SITE DEVELOPMENT PLANS FOR BANK OF AMERICA

SECTION 15, TOWNSHIP 27, RANGE 24 BLOOMINGTON, HENNEPIN COUNTY, MN

PRELIMINARY - NOT FOR CONSTRUCTION
BANK OF AMERICA
 PREPARED FOR
OPPIDAN
 BLOOMINGTON, MN
 SHEET NUMBER
C501

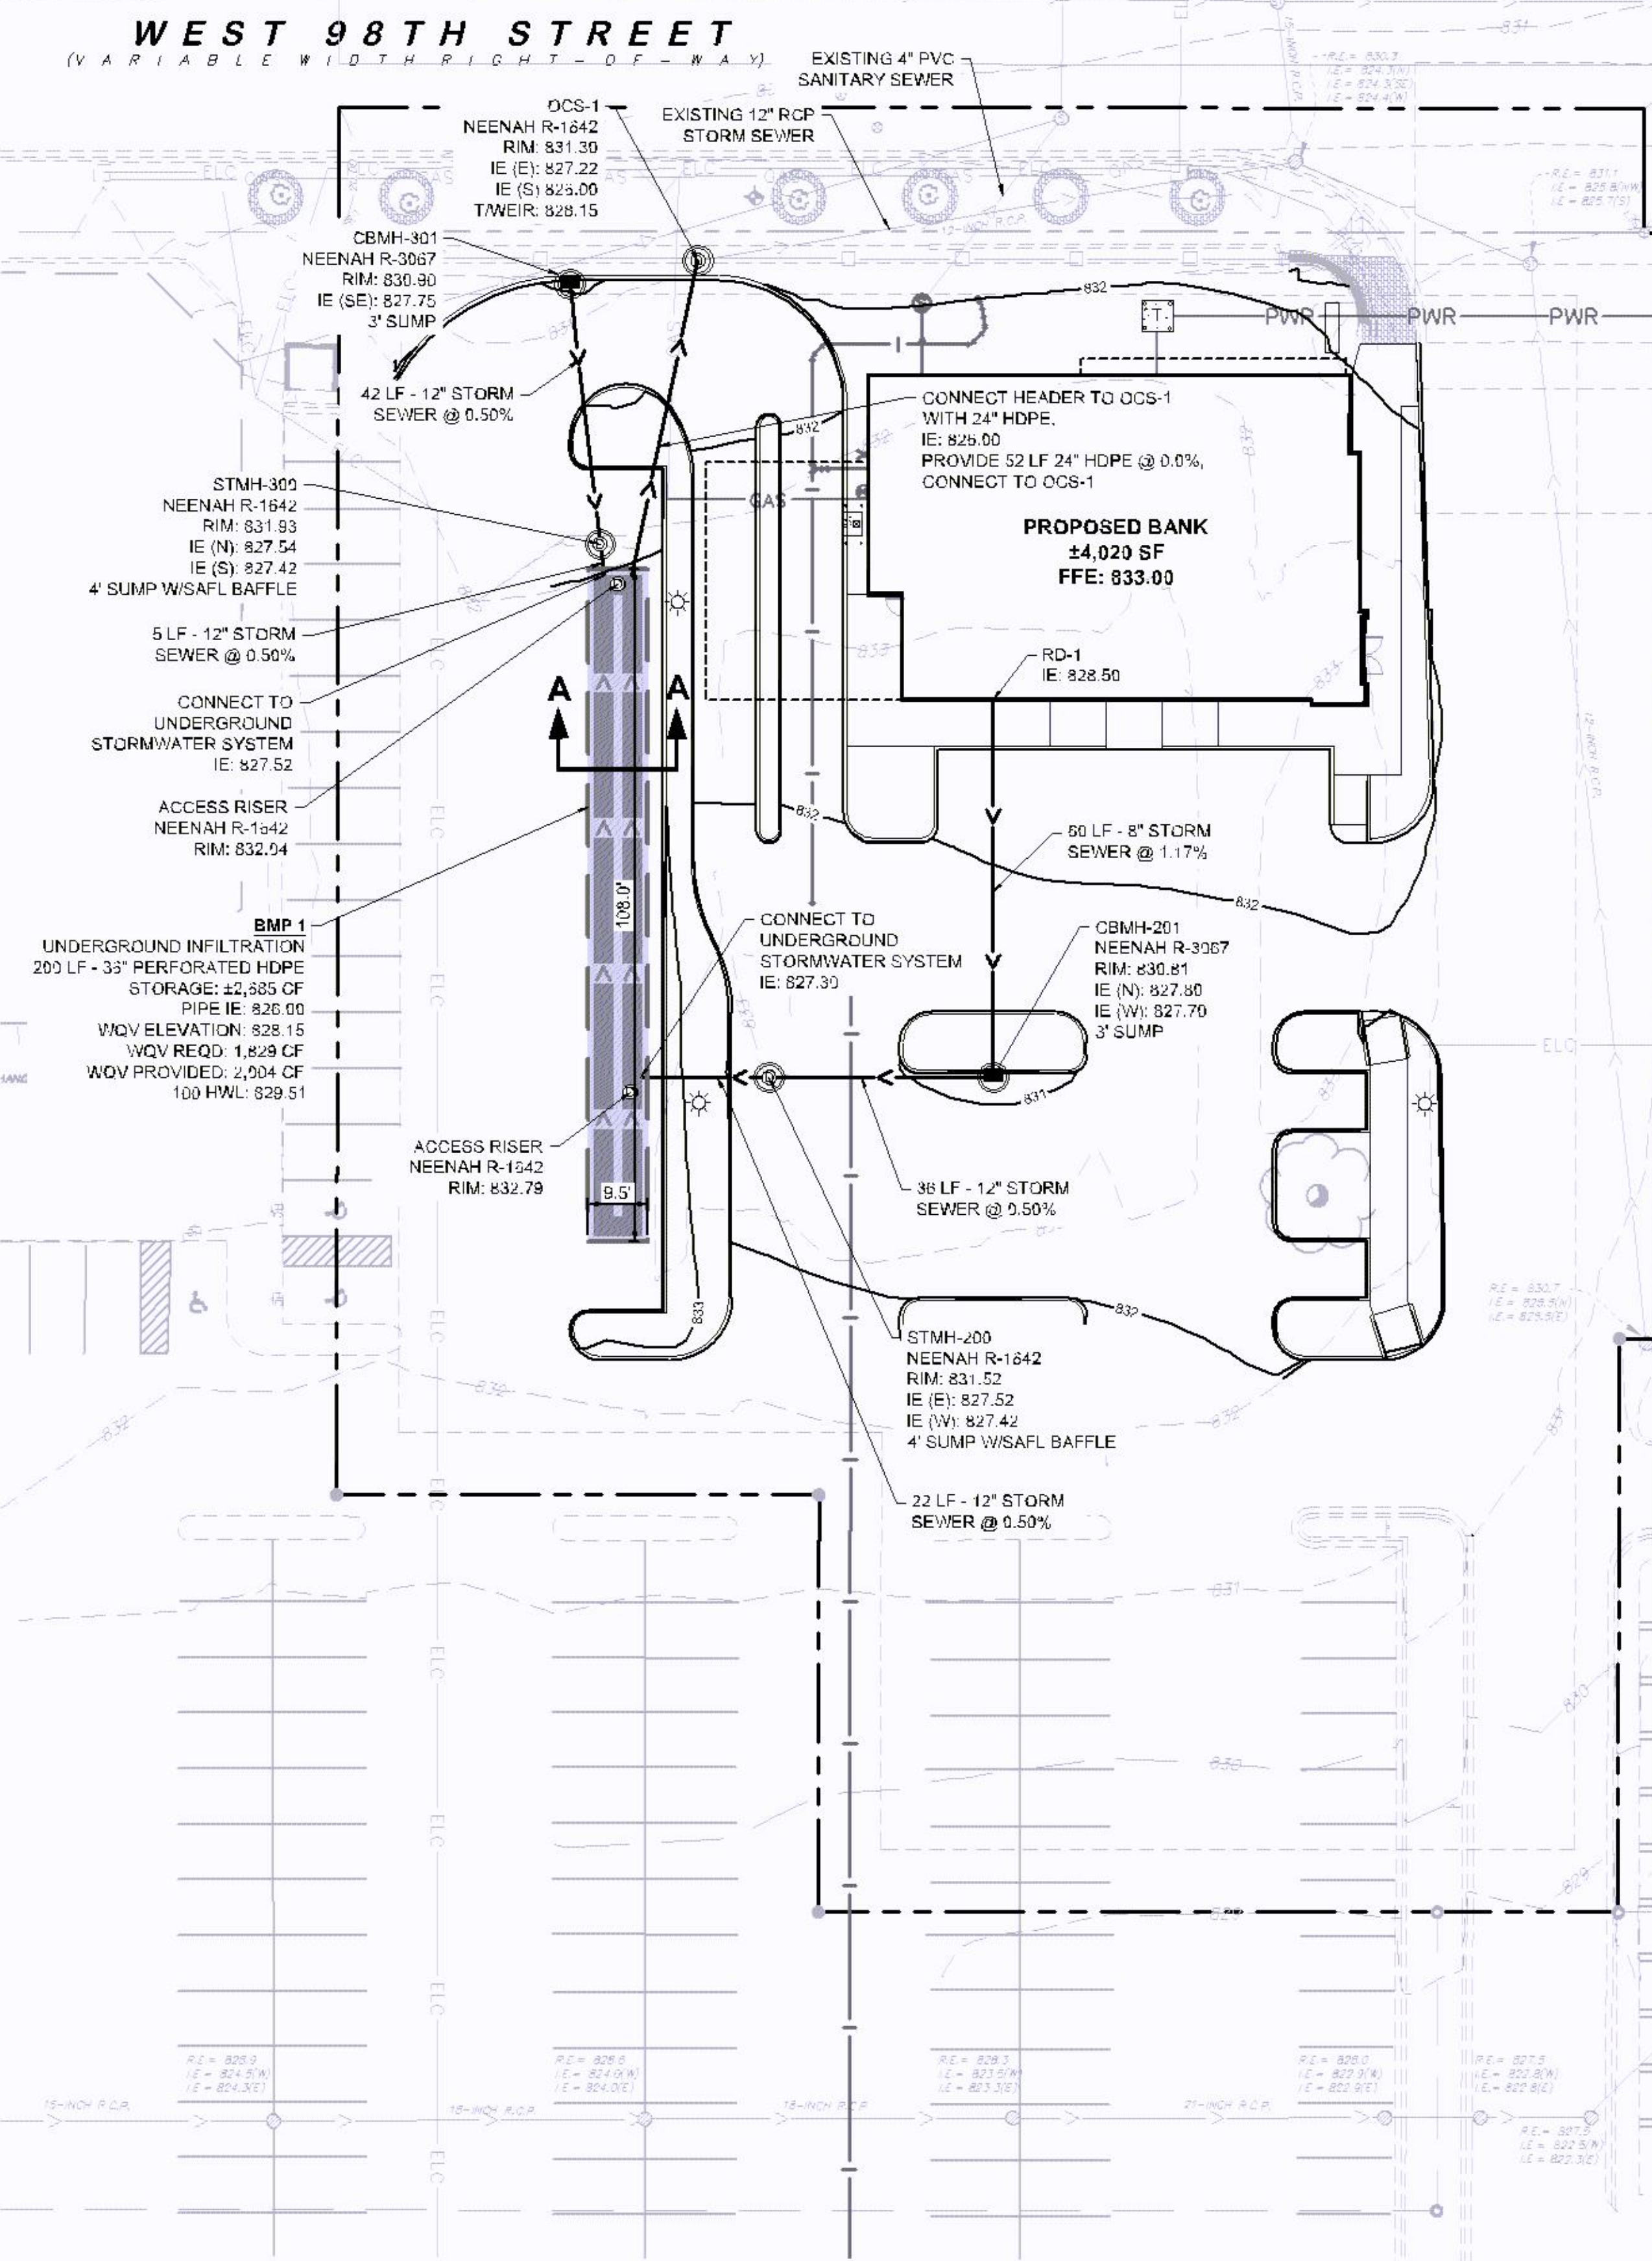
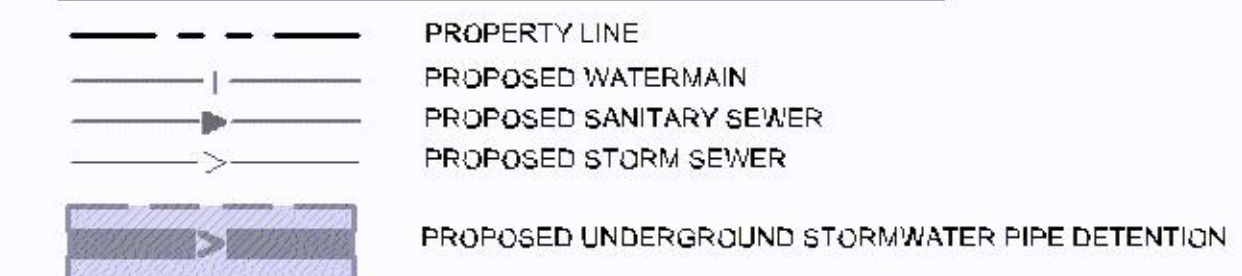
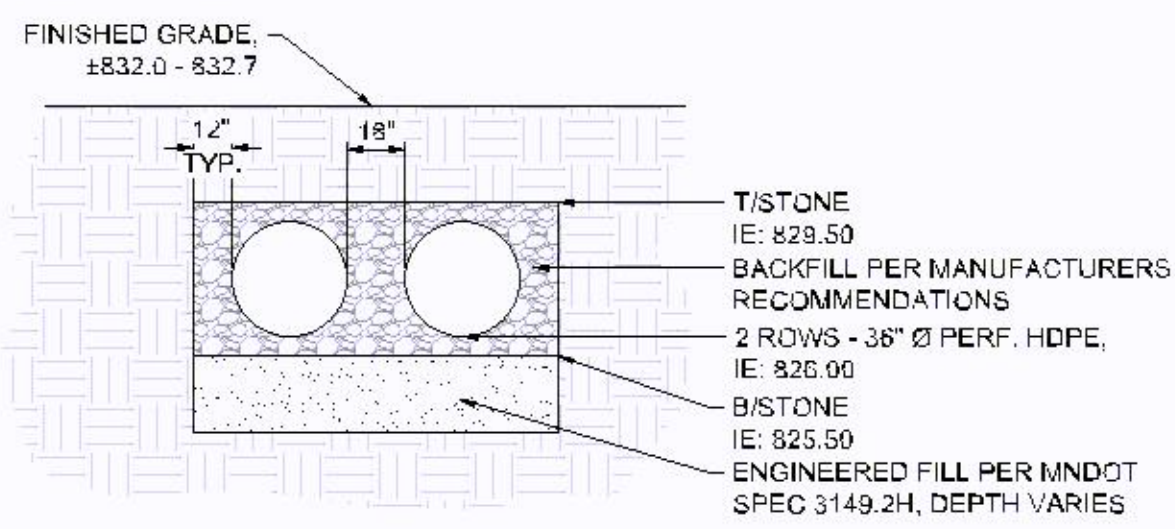
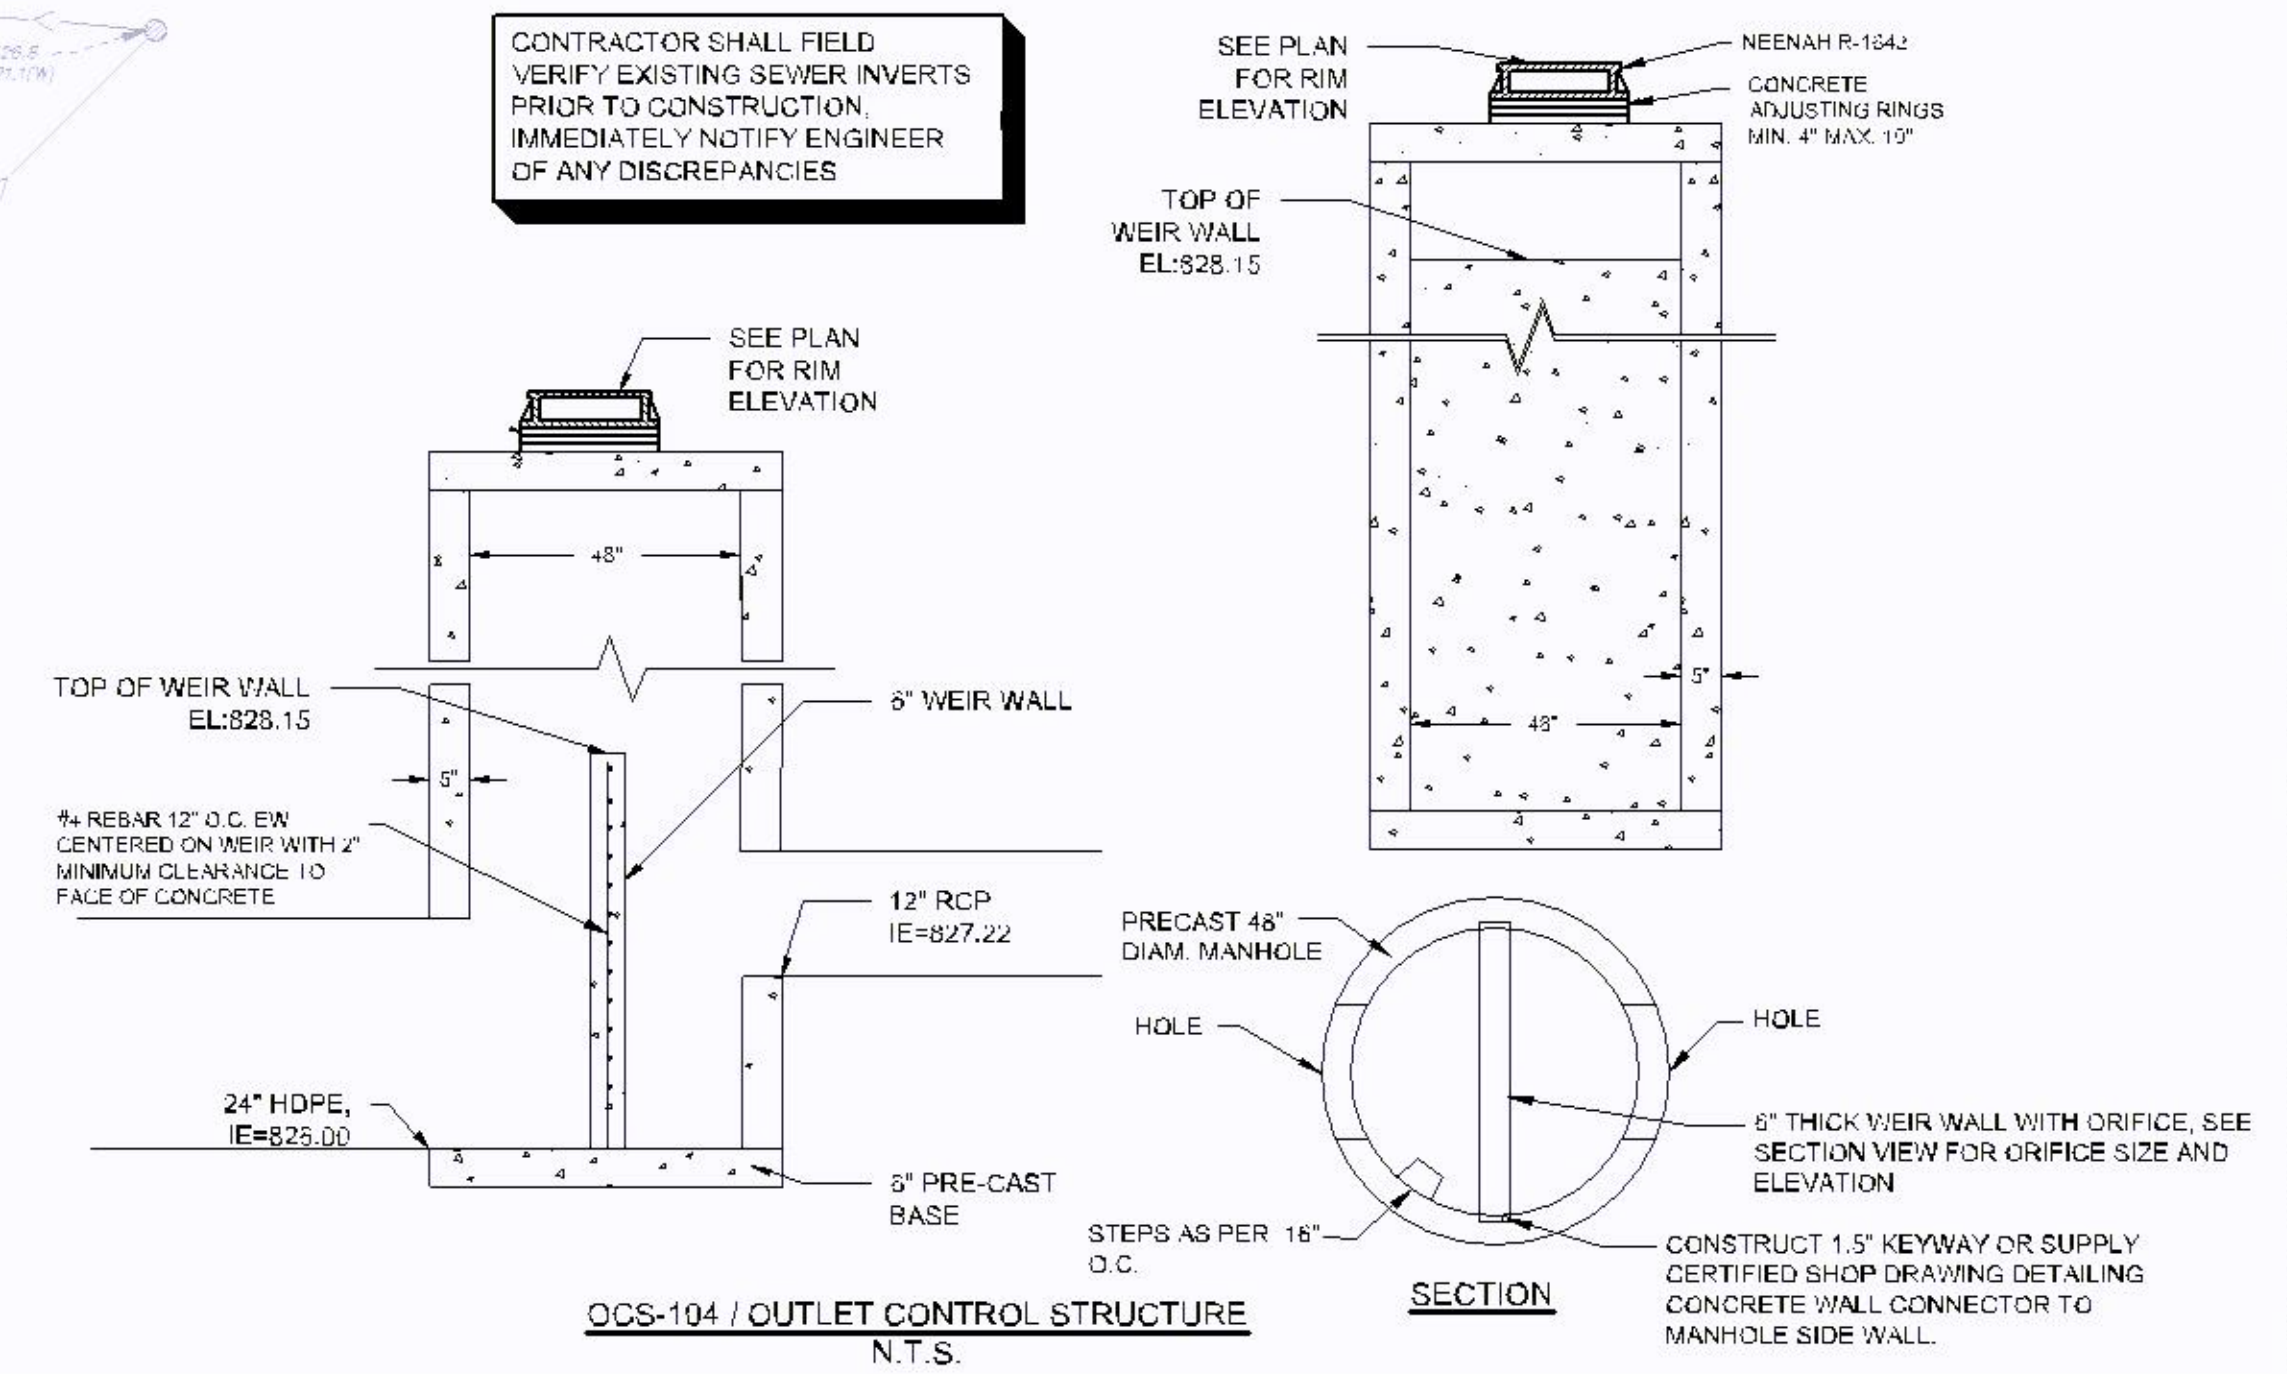
Engineer to provide Bloomington Engineering with copy of approved test results.

SHEET NUMBER
C600

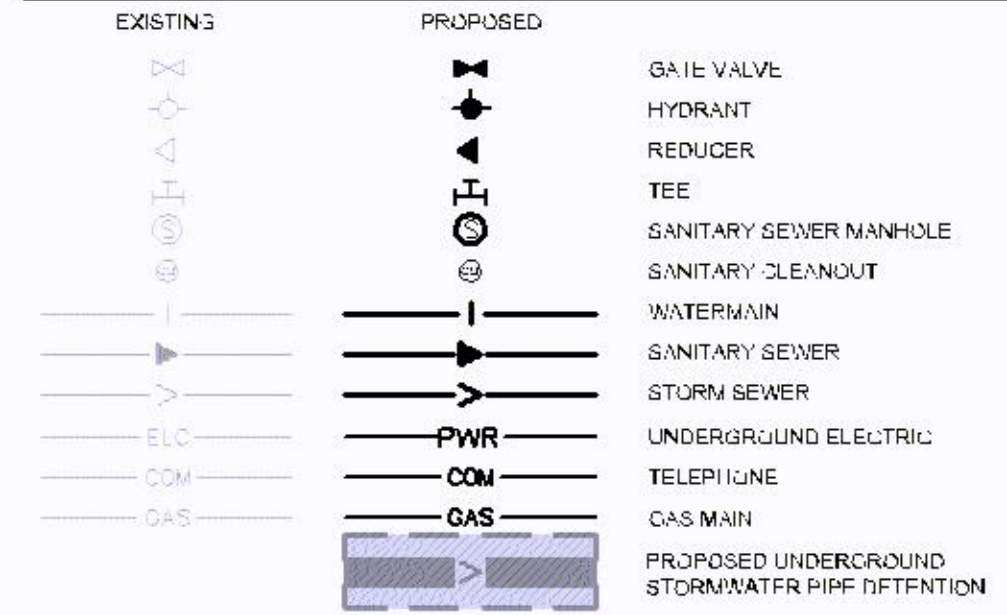
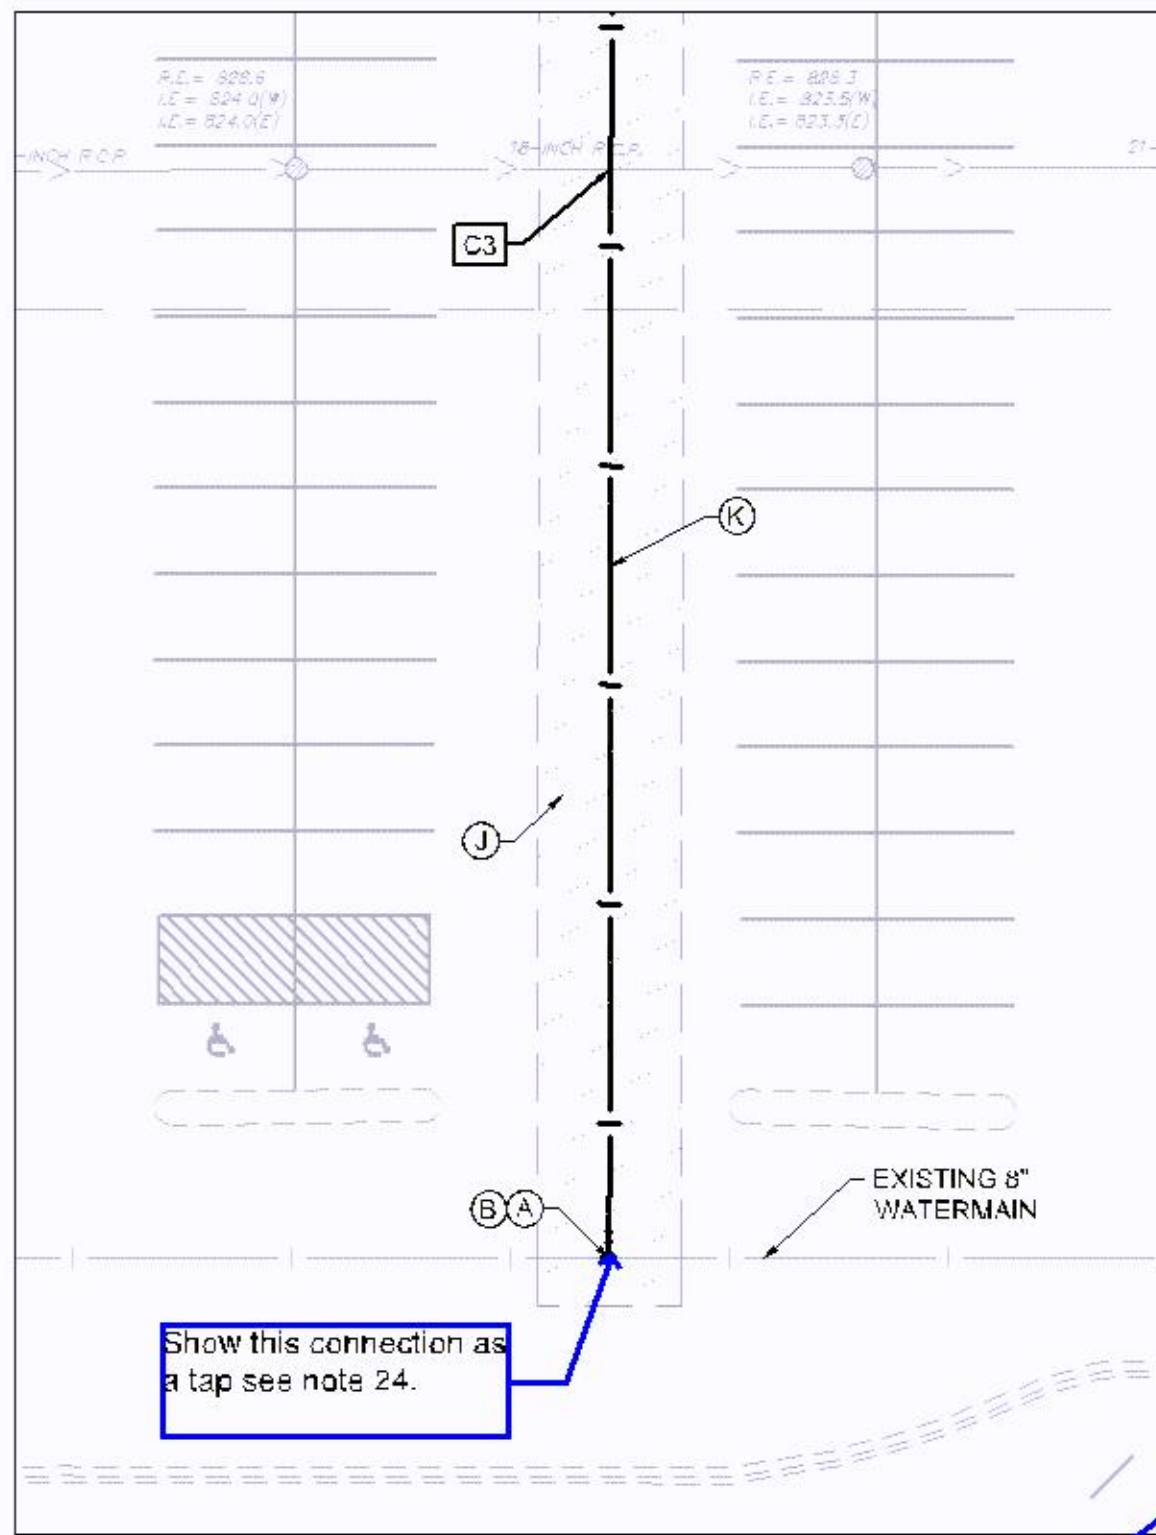
If any utility work occurs in 95th St, keep removal limits out of vehicle paths and extend to lane lines.

City records indicate this may be a 60 year old 5" Asbestos Cement Pipe Sewer service. There were some indications of issues/repairs in the past but not much detail is known. Project Engineer and Contractor should verify the condition of the pipe via CCTV for the owner. It may be necessary to rehab/line or replace the service.

Sewer will be abandoned back to this MH, show new service pipe straight into the Bldg and another MH will not be needed. This will eliminate the water and sewer service crisscross.

Need a new valve to perform testing of the new water main and straighten out water services.

Please clearly indicate all pipe sizes.

Use SDR26 or Sch 40.

Only Stainless.

Notes 31 - 34 are repeated.
